## Application for Works Approval

<b>Works Approval Number</b>	W6603/2021/1
<b>Applicant</b>	Big Bell Gold Operations Pty Ltd
<b>ACN</b>	090 642 809
<b>File number</b>	DER2021/000500~1
<b>Premises</b>	Big Bell Project - Cue Gold Operations Mining Tenement M20/98 and M20/197 As defined by the premises maps attached to the issued works approval
<b>Date of report</b>	28/02/2022
<b>Decision</b>	Works approval granted

**Figure 4: Relationship between SAR and EC of irrigation water for prediction of soil structural stability (ANZECC, 2000). The red line represents Indicator pit water and the purple arrow represents Accelerator.**

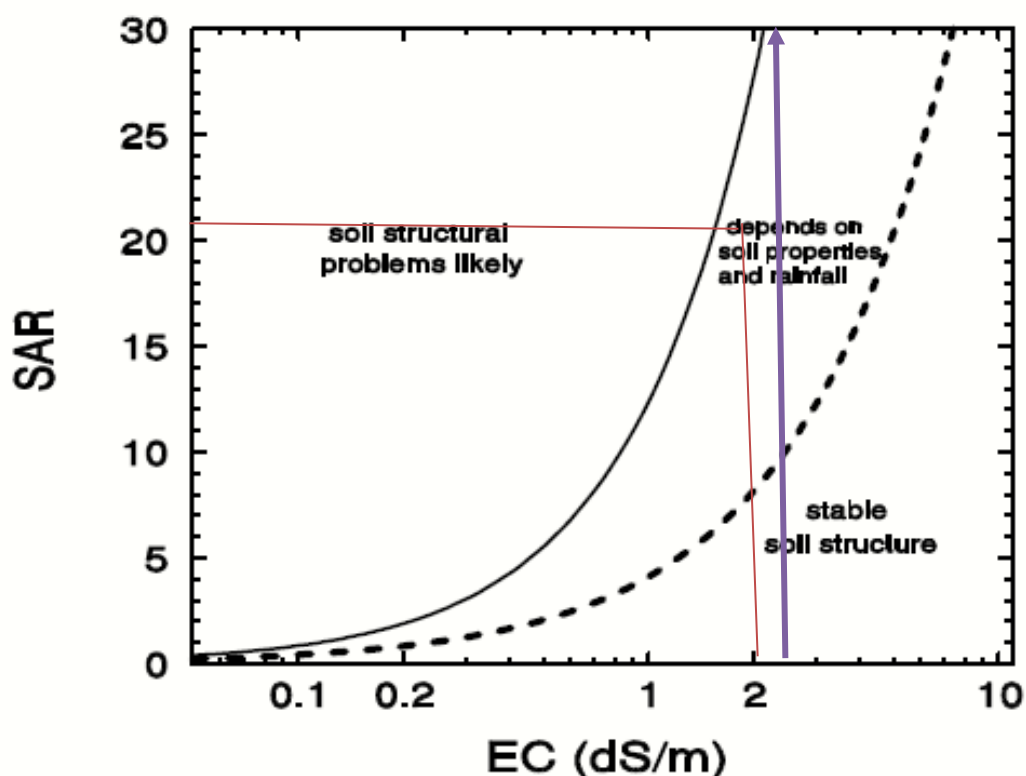
To evaluate the quality of the irrigation water by superimposing the electrical conductivity (EC) and SAR values on Figure 4, to see if it will affect soil. EC was calculated using the formula:

Based on the diagram above, it is expected that the ongoing discharge of the dewatering effluent to land could destabilise the underlying soil structure, causing soils to become dispersive and allowing fine particulates to be eroded and transported in surface flows.

To manage the risk of soil erosion, the following conditions have been added to the works approval:

- Use of rock bunds or similar structures to slow the rate of water flow and to trap suspended solids from runoff, from the discharge area; and
- Mixing powdered gypsum or calcium carbonate with the dewatering effluent before discharge to lower its SAR value, so that the structure of soil in the discharge area is not destabilised.
